# A message from Technical Standards

## CitiPower/Powercor Technical Standards Update for July 2019

# EM151, 155, 161 & 165 Gas switches

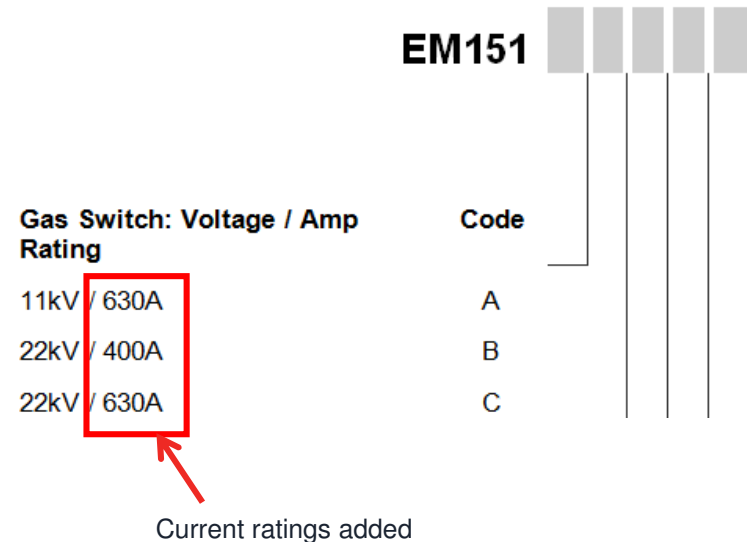
- Technical Standards EM151, EM155, EM161 & EM165 (Gas switches) have been updated to include current rating in the variable selection codes
- Technical Standards EM151 & EM161 have also been updated to permit the use of SL27 crossarms with gas switches

- The change has occurred to improve the use of the standard and provide further guidance to ensure the correct gas switch and associated lead connections are selected for the required current rating
